PRELIMINARY DRAINAGE REPORT

CATTLETRAK TRUE HOMES (Case No 19-ZN-2016)

PROJECT NAME: 19-ZN-2016 CATTLETRACK VILLAGE

DRAINAGE COMMENTS / DRAIN:

Lower Indian Bend Wash ADMP

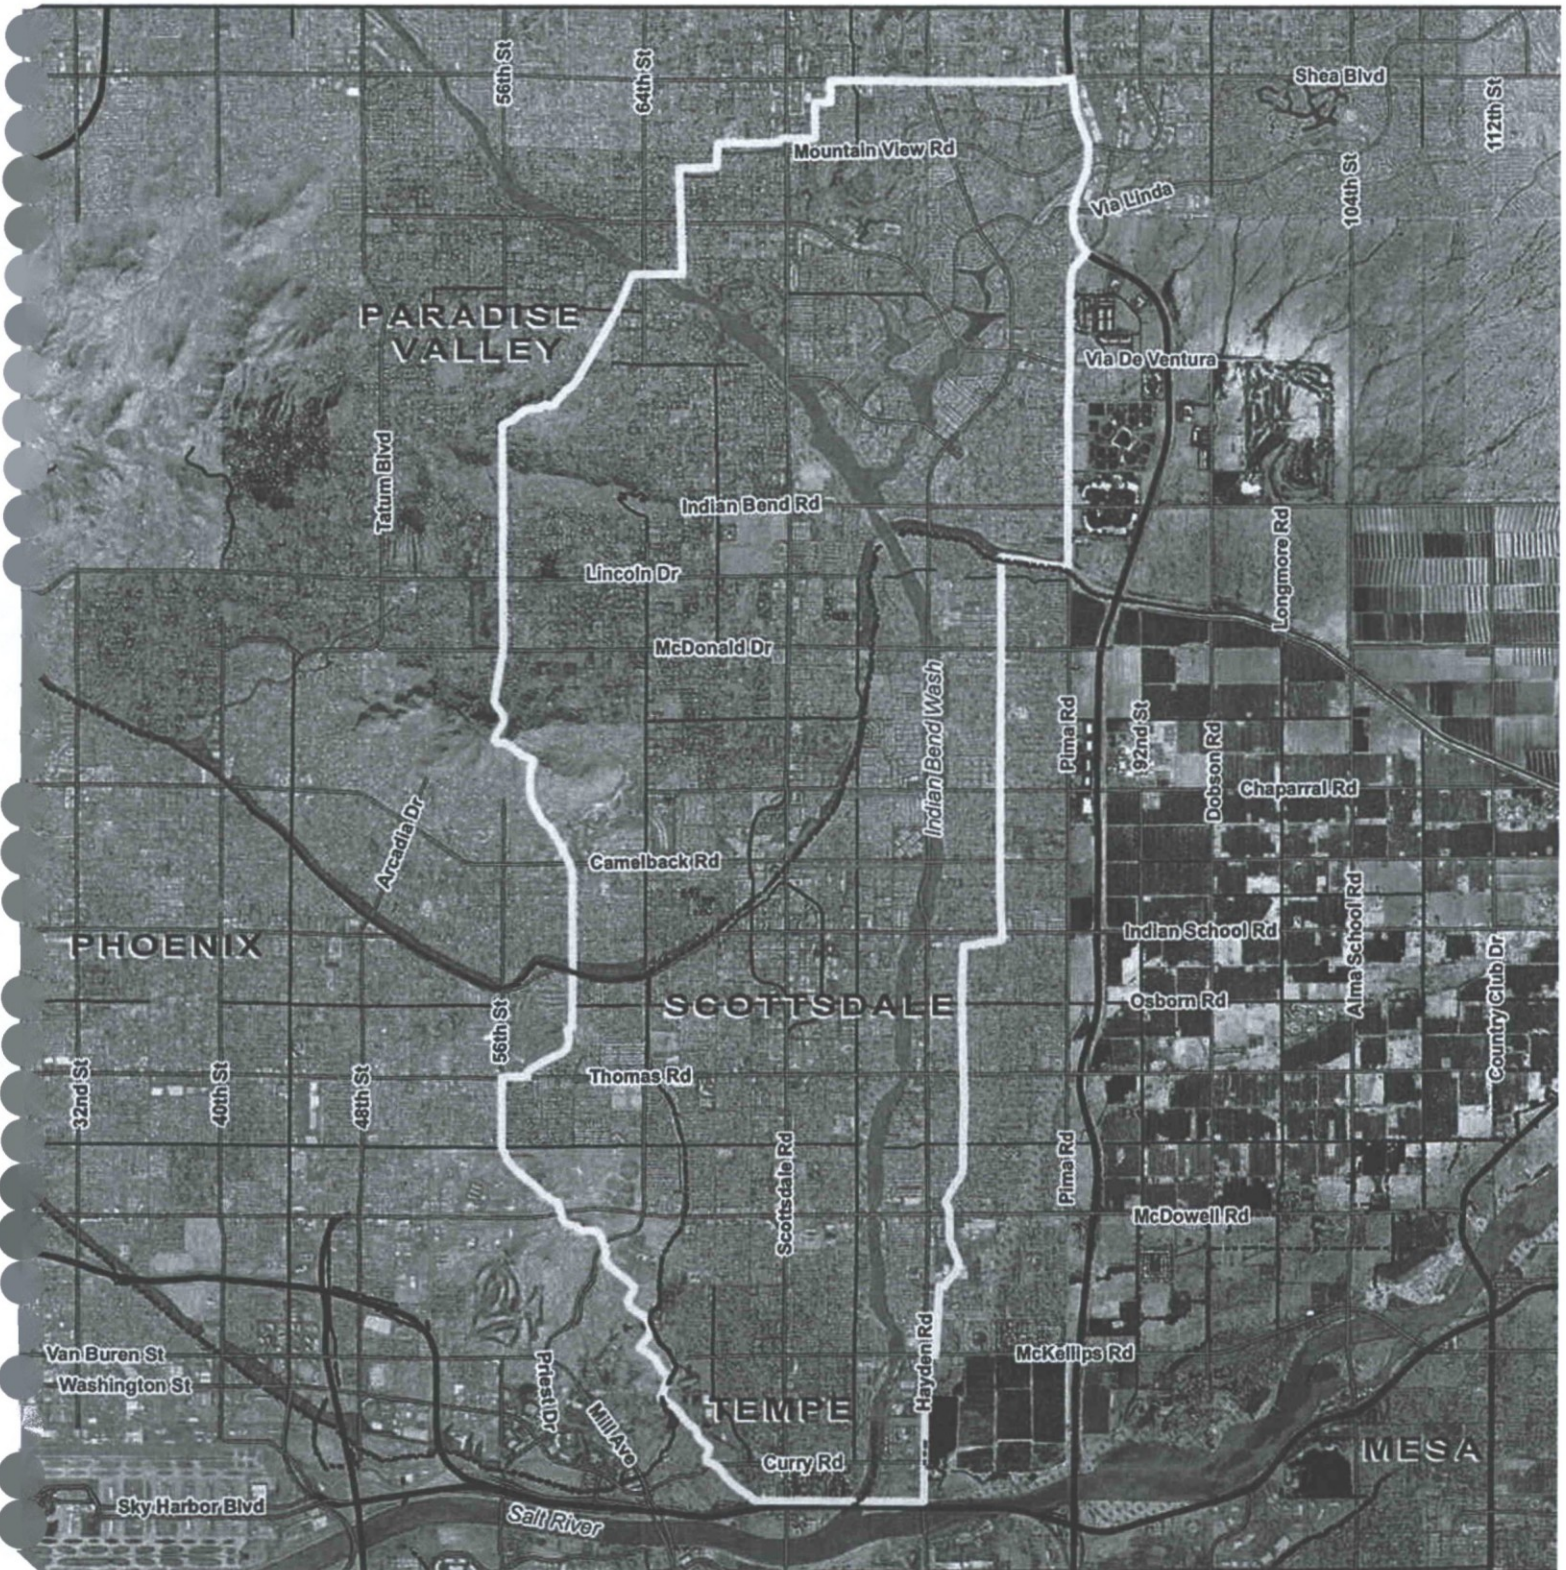
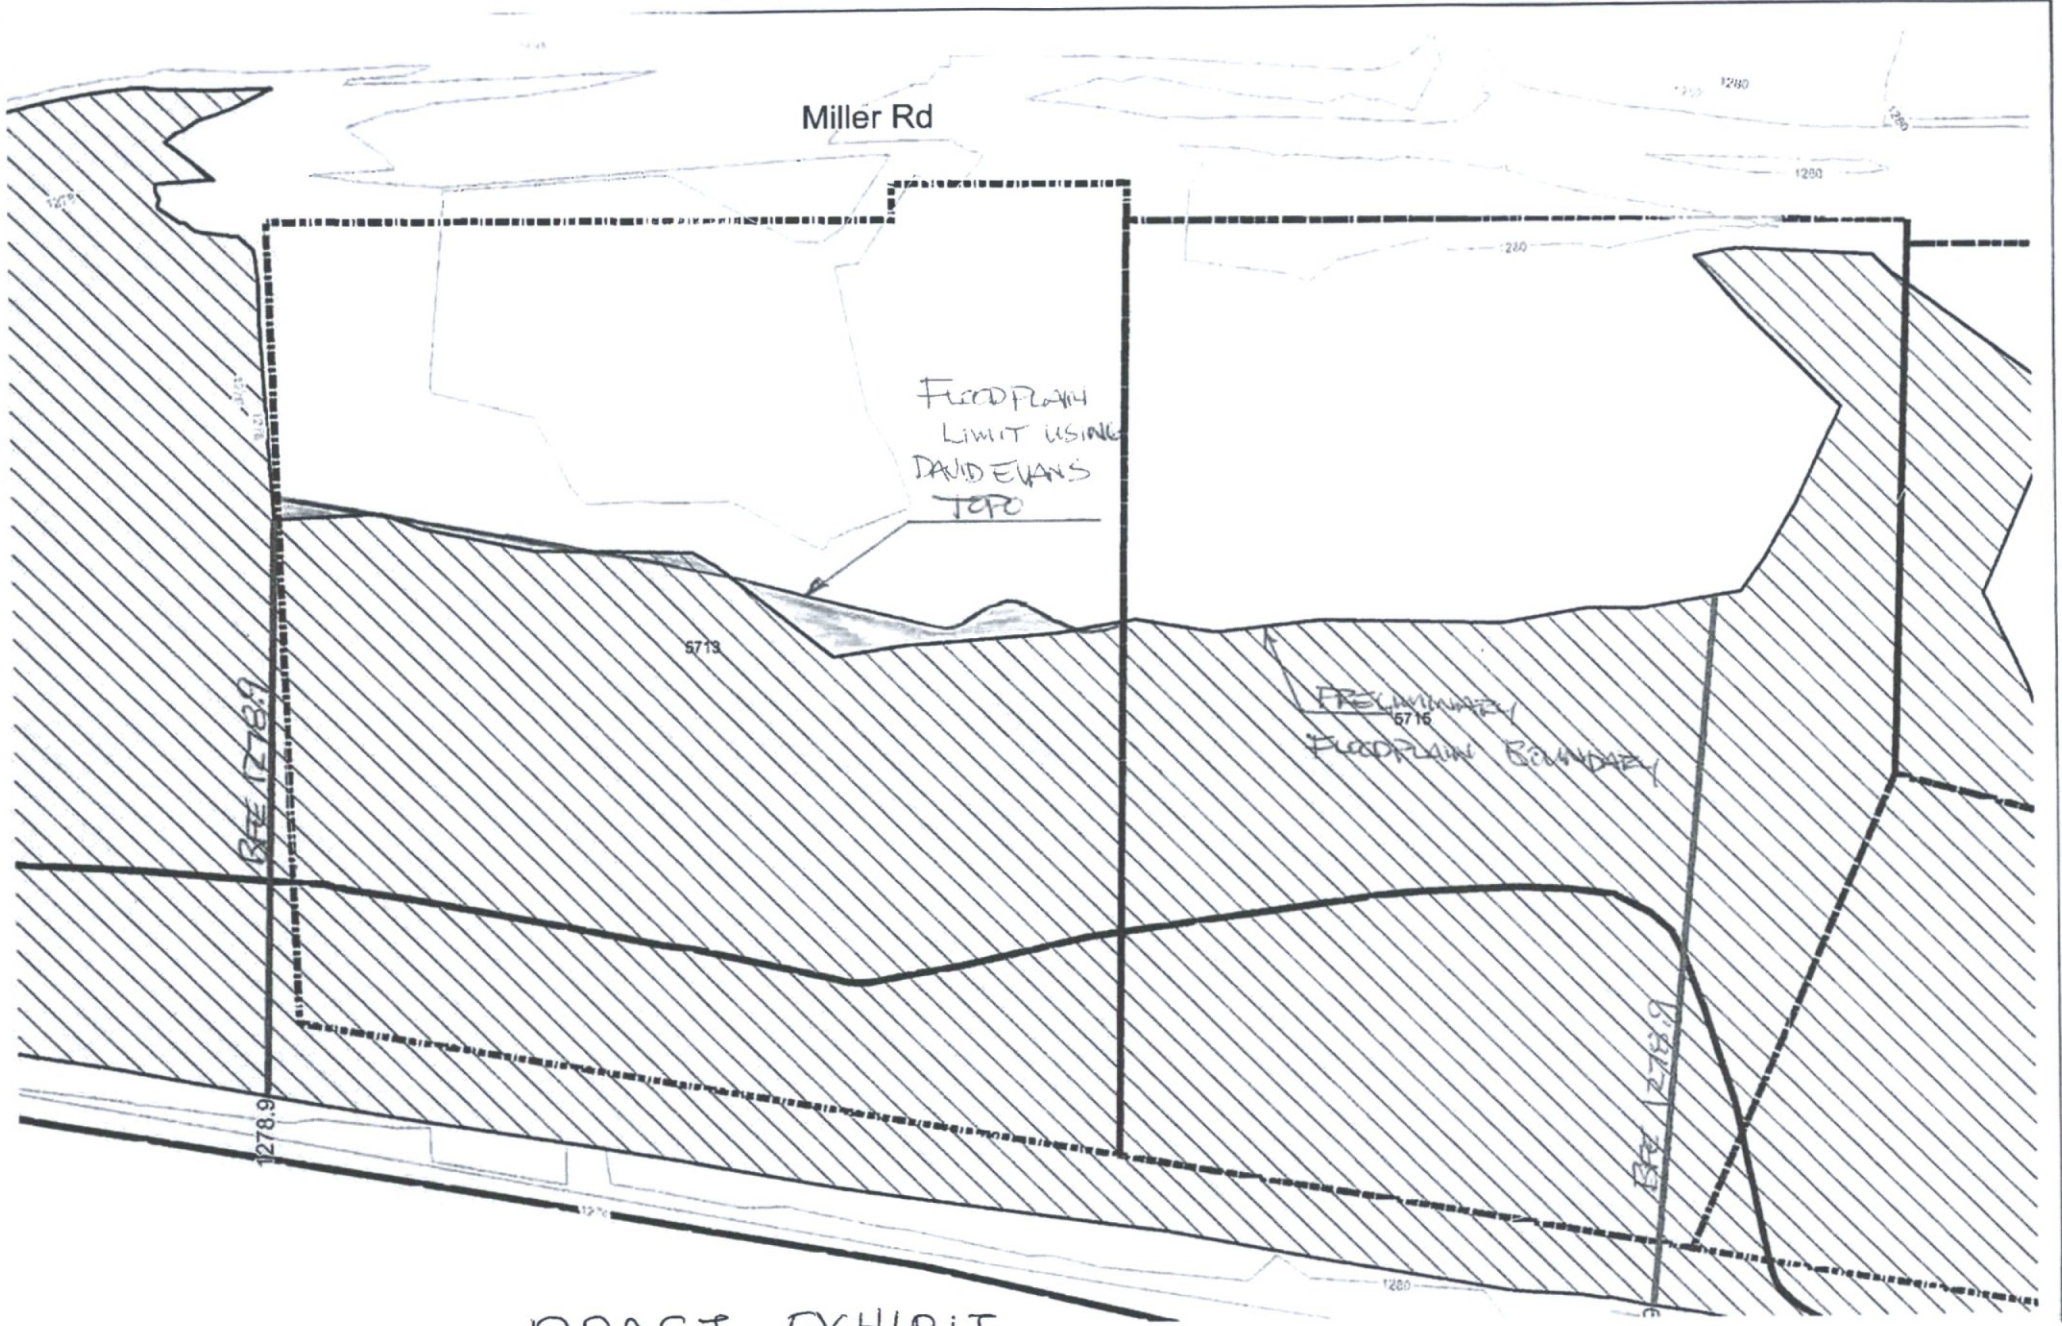
- 15. Label all the full size exhibits with specific titles in the drainage report. 10/4/16
- 16. The Best Available Data for the Flood Zones in this area is from the FCDMC Lower Indian Bend Wash ADMS. The City does not support the CLOMR request because the flood zone is changing from A to AH. Please design the site for the future flood zone AH per the FCDMC Lower Indian Bend Wash ADMS. 10/4/16

CONCEPTUAL GRADING & DRAINAGE PLAN
FOR 5713 N. CATTLETRACK ROAD
CITY OF SCOTTSDALE, ARIZONA

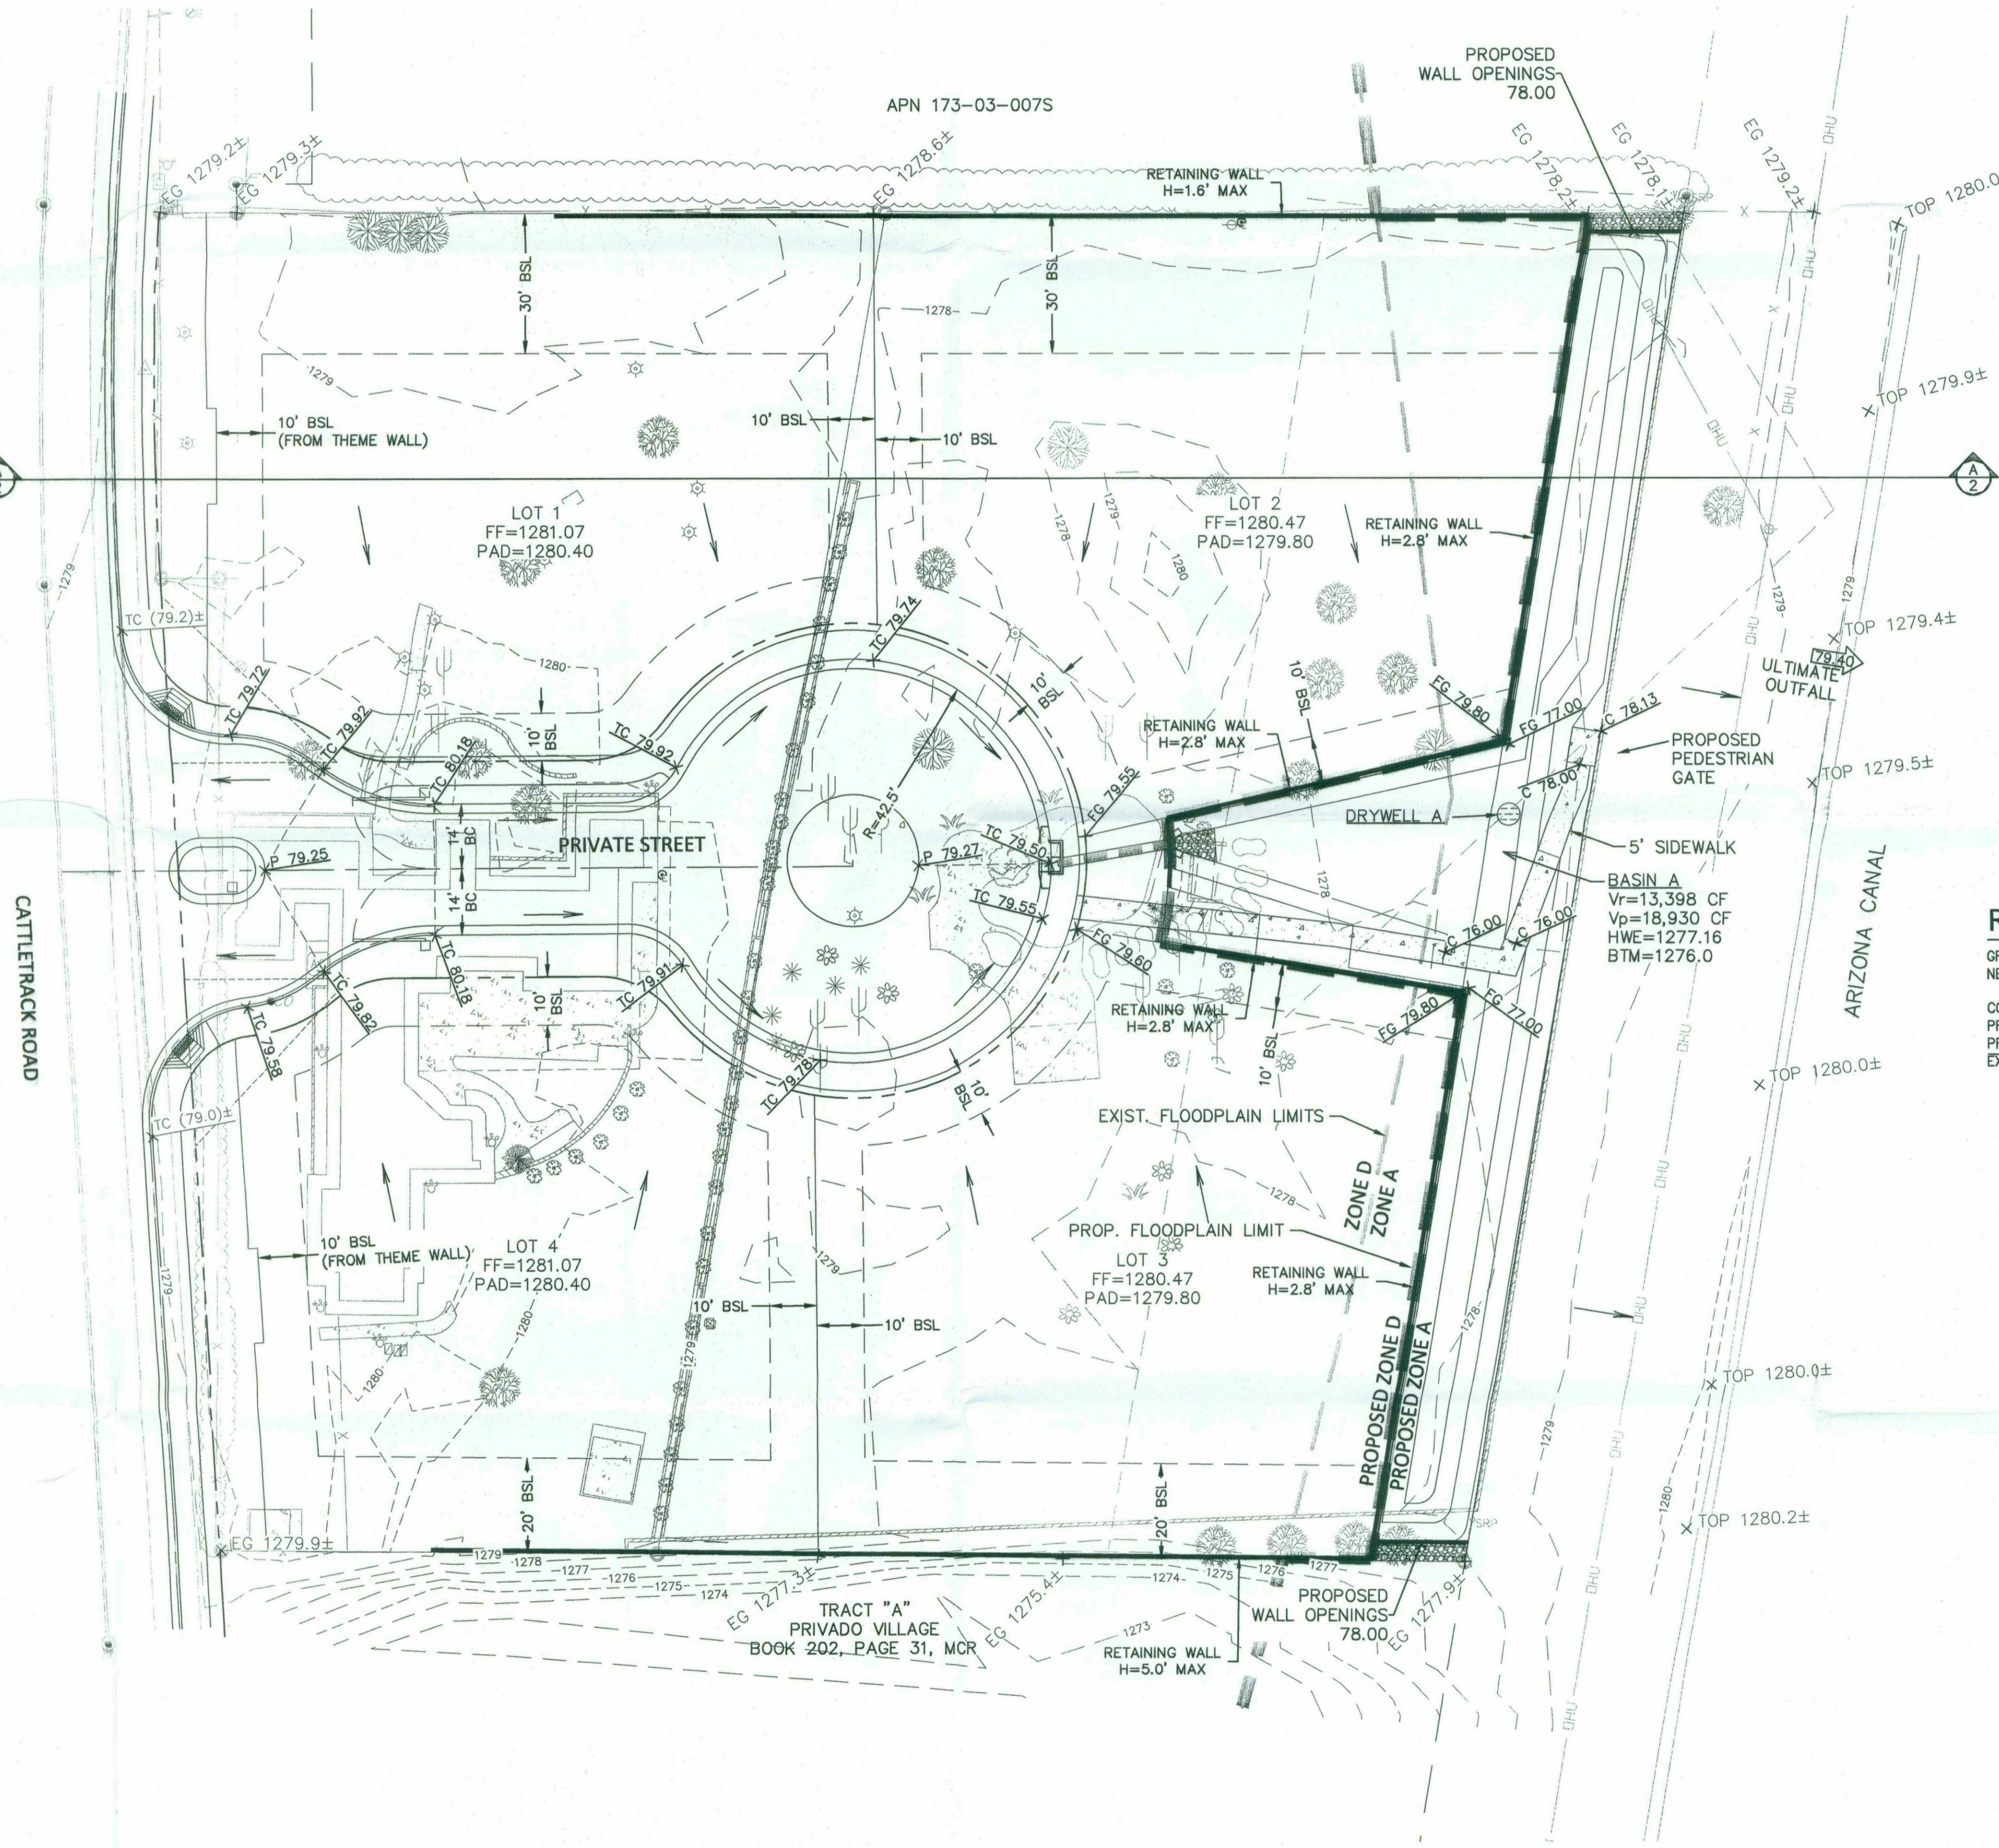
the proposed Flood Zone AH area and delineation limits line on the site plan. Use the FCDMC Lower Indian Bend Wash ADMS for this information.
